OFFICE OF THE
GENERAL COUNSEL

In the Matter of
ADVANCED MEDICAL SYSTEMS, INC.
Material License No. 34-19089-01
Docket No. 30-16055-ML-REN

USNRC Comment: The structural integrity inspection conducted by R. Shewmaker of NRC Headquarters has been completed. We will forward the complete inspection report to you as soon as it is available. The inspection revealed several concerns which may have an effect on several issues discussed in the DFI (e.g., the Emergency Plan, and the Decommissioning Plan). Therefore, in your response to this letter, please address the issues discussed in the structural integrity inspection report.

Figure A-1. Masonry pilasters and steel columns.

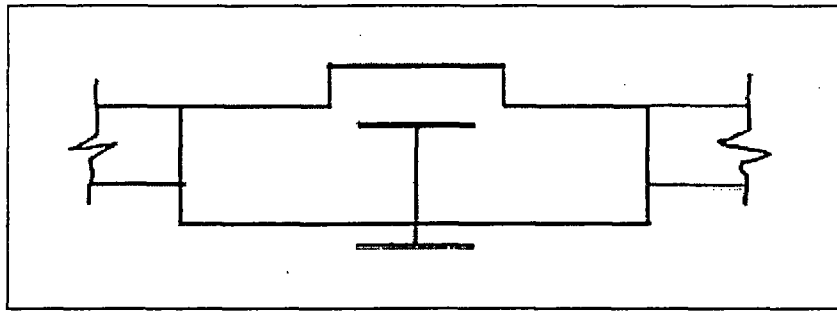
3.1 CONCERN-4/2/1: *The 1958 design, development and construction...encompassed the integration of a then existing warehouse/industrial building, with masonry load bearing walls and steel trusses as the roof framing steel...* This item was not a concern but a response is needed for clarification.

3.1 RESPONSE: The warehouse/industrial building referred to is not a complete load bearing masonry wall building with steel trusses, although at first glance it may appear to be. The building was constructed in 1934 as rectangular in shape. The east-west walls, the walls in the longer dimension (~100 ft), are non-load bearing masonry in-filled walls between steel-riveted columns that support the steel trusses. Some small amount of roof load between the trusses was originally carried by the east-west masonry wall, but this load was one-half of a purlin load, thus the wall typically would not be considered a load bearing wall. The tops of the east-west walls are basically unsupported in the out-of-plane direction except at the columns. At the columns, the masonry is placed flush with the column webs and a pilaster is built around the column flanges facing the original exterior of the building, with about six inches of brick covering the flanges. The sketch in Figure A-1 demonstrates the construction. Based on research done in the last 10 years (Henderson, et al., 1995), unreinforced masonry in-filled buildings provide excellent seismic resistance in low to moderate seismic zones. Although the 1935 building is not a true in-fill since the upper masonry walls are not confined by beams, the fact that they are in-filled within the floor and columns should provide lateral capacity of the building superior to a typical unreinforced load bearing wall. This is especially true where the old windows were filled in with masonry.

Figure A-2. Ceiling water damage.

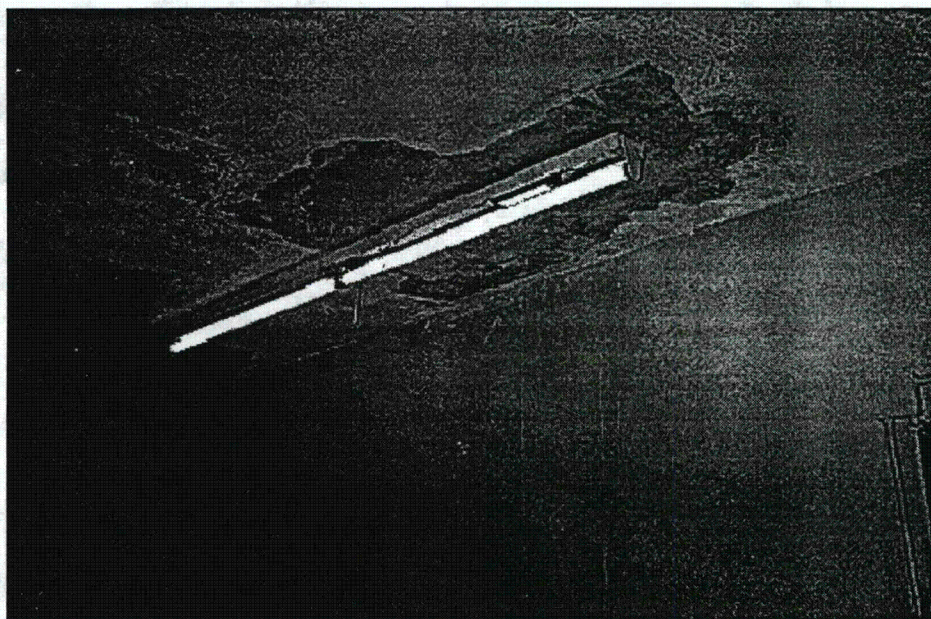
Agency Comment 4: The second floor concrete slab in the area where it forms the ceiling of the hallway in front of the hot cell and the radiography room, which exhibits the effects of previous fluid penetration through the slab from above [should be addressed].

5.1 RESPONSE: Two chases, one for electrical service conduit and one for ventilation, penetrate the second floor from the first floor into the equipment room on the second floor. The equipment room has a 10-inch riser around its perimeter, including the two doors, giving the impression that approximately 850 gallons of fluid would have to be spilled for a leak

outside the area to occur. This may have been the original intent; however, at both the conduit and ventilation chases, the risers are only two inches. In addition, at the ventilation chase, the riser has a 1½-inch notch in it. Thus, the maximum fluid that can be contained within the equipment is about 40 gallons. Therefore, the fluid runs over the ½-inch riser, down the chase onto the false ceiling. The first time a leak of significance occurred, the fluid collected in the false ceiling and was held there until the plaster of the false ceiling gave way as shown in Figure A-2.

This leakage caused no deterioration of the second floor slab's structural strength, and the fluids did not penetrate the concrete floor slab. There is no visible degradation of the floor slab, and it is highly unlikely there has been any degradation. In addition, the main part of the equipment room is over the radiography room where the floor slab is 2-feet thick.

Figure A-5. Cracking on the inside wall.

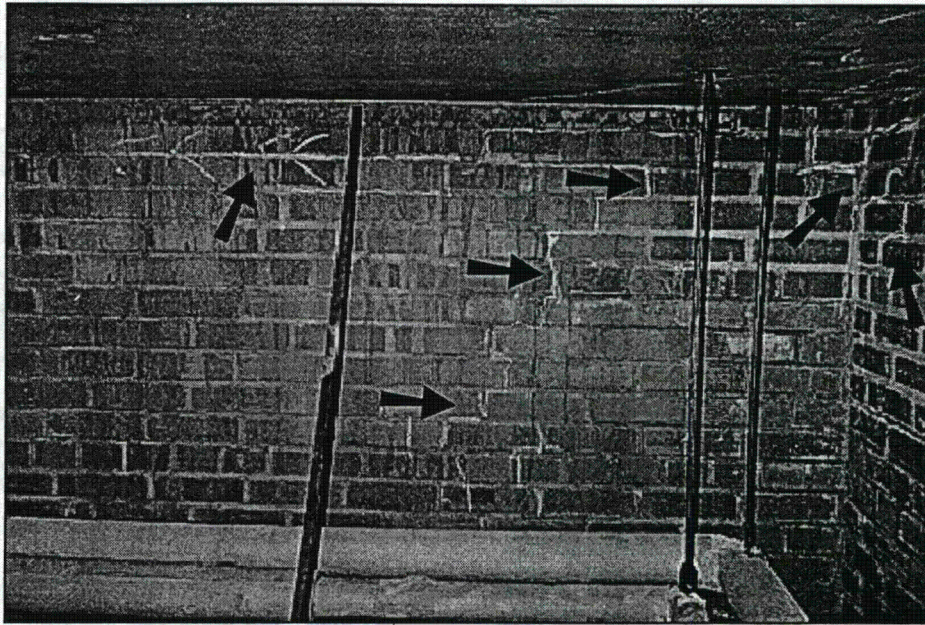
1. *The depth and extent of cracking, structural impact, and any measures identified as necessary to repair the cracking identified in the load-bearing masonry wall in the 1958 building's southeast corner. Associated distress that could limit the facility's ability to continue to provide protective confinement of the radioactive materials should also be addressed and corrective actions identified as necessary.*

5.7 RESPONSE: As described in the NRC report, cracking does exist and is shown in Figure A-4. From the outside, the cracking appears to stop just short of the area where the second floor slab ties into the common wall brick. From inside the building below the second floor, it is evident that cracking does extend through the wall; however, it is not continuous, i.e., the cracking on the inside of the wall is almost an opposite pattern, as shown in Figure A-5.

From inside the building above the second floor, the east and south walls in the corner show no cracking; however, as shown in Figure A-6, there are four cracks in the second floor slab that are visible to the human eye. One very large crack is nearest the corner, is at an approximate 45° angle to each wall, has a width of one-half inch, and has a length from wall to wall of about six inches. Based on the width of this crack, it must be assumed that the crack continues through to the slab edges underneath both the east and south walls. No reinforcing steel was found in this crack. A second crack runs almost parallel to the south wall, appears to cross the third crack, and then merges into the fourth crack. The third and fourth cracks are also at about a 45° angle to each wall. Based on the width of the crack nearest the corner, it appears that the southeast corner has moved southeast a distance of as much as $\frac{1}{2}$ to $\frac{3}{4}$ -inch. These floor cracks seem to indicate excessive bending moment in the floor slab at this corner, which would be indicative of significant settlement at the corner. Underneath the second floor slab, matching crack patterns were found. It was determined that the as-built dimension of the floor slab was six inches.

Figure A-7. Wall movement at purlin in corner.

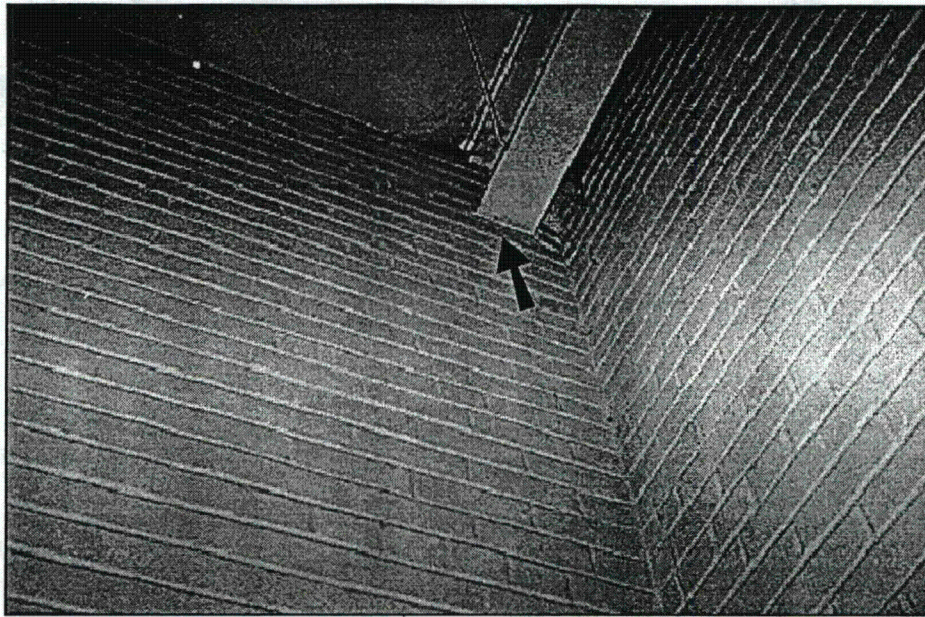
5.13 CONCERN-7/4/12: *On the inside of the 1958 building at this purlin bearing there is evidence of movement between the bearing wall and the purlin in the longitudinal direction...is not known...which structural element remains with the permanent movement...*

5.13 RESPONSE: This movement appears to be approximately ¼-inch as shown in Figure A-7. Although such movement may occur for a building having a mix of materials involving steel, concrete, and masonry as main structural elements, this movement must be attributed to the corner moving to the southeast at the second floor. According to Dwg. S-1, all beams bearing on the masonry wall have wall anchors. These anchors are two angles, 6 inches by 4 inches by 3/8 inch. Thus, the wall anchor should be holding the common masonry wall from moving further eastward at the top. No sign of distress in the veneer

Figure A-8. Purlin and Wall Movement.

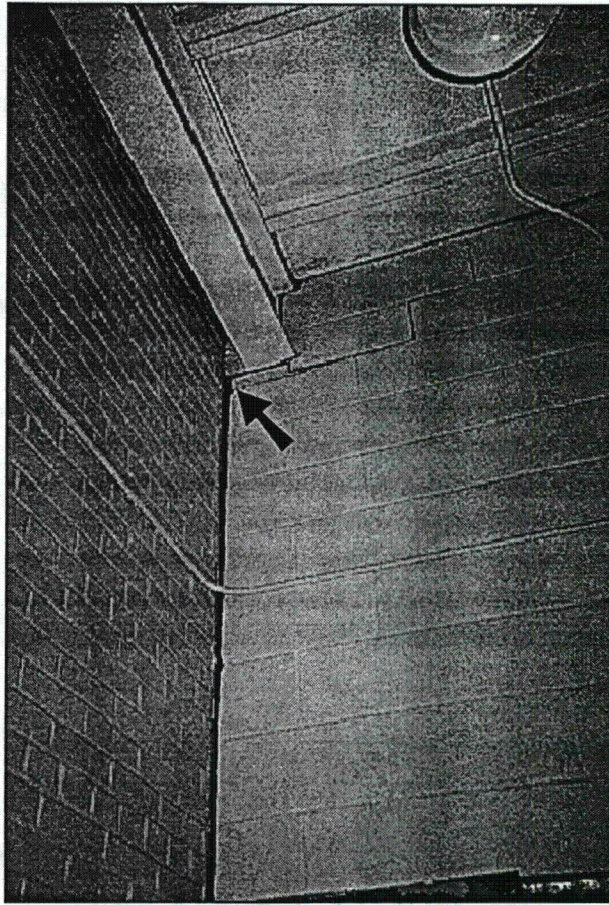
5.15 CONCERN-8/2/1: *The distress of the east wall near the northeast corner of the 1958 building is associated with a rupture type failure...rupture line is most pronounced in a verti-*

cal direction just adjacent to the northeast steel column... rupture surface is generally through every other course of concrete block and does not follow a saw tooth pattern...

Figure A-9. Lobby stone showing salting.

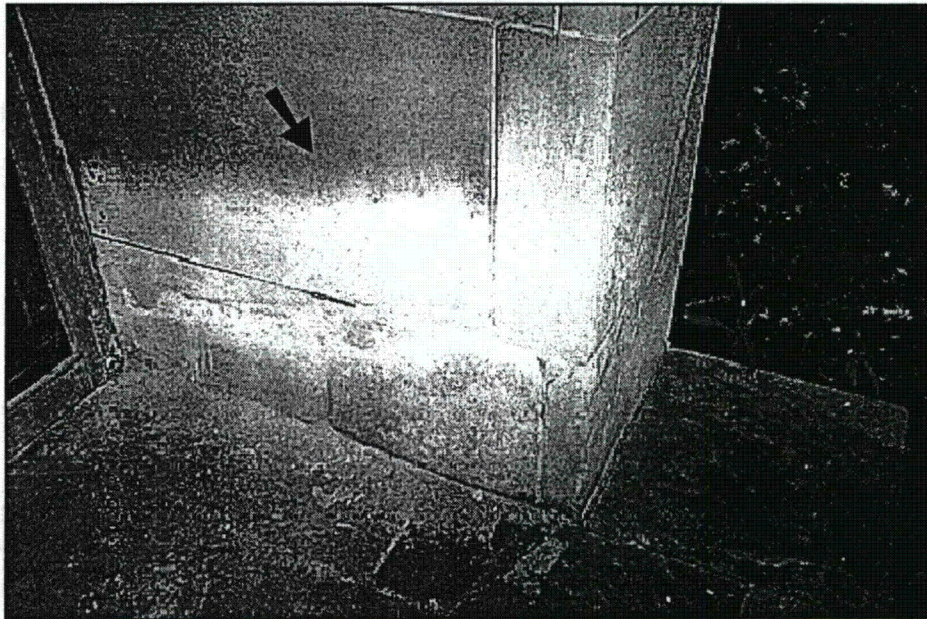
5.16 CONCERN-8/2/17: *In addition, the stone corner and stone return at the northeast corner of the 1958 building show displacement and rotation at the corner with failed joints.*

5.16 RESPONSE: It is believed that the failure of the stone corner at the bottom of the wall has resulted from a totally different cause, but may have something to do with the in-filled wall movement at the second floor. This stone corner is located next to the lobby entrance of the 1958 building. Upon inspection of the site, it is very apparent that the joint failure of the mortar has been caused by salting the lobby entrance to remove snow and ice. The stone facing is discolored where the salt was thrown as shown in Figure A-9, and where discoloration has occurred, mortar in the joint was attacked. At a distance of approximately one foot north of the south corner of the stone, there is no stone discoloration and the joint is intact. As a result of joint failure, the stone has fractured. Again this is a life-safety issue and has no bearing on the structural stability of the 1958 building.
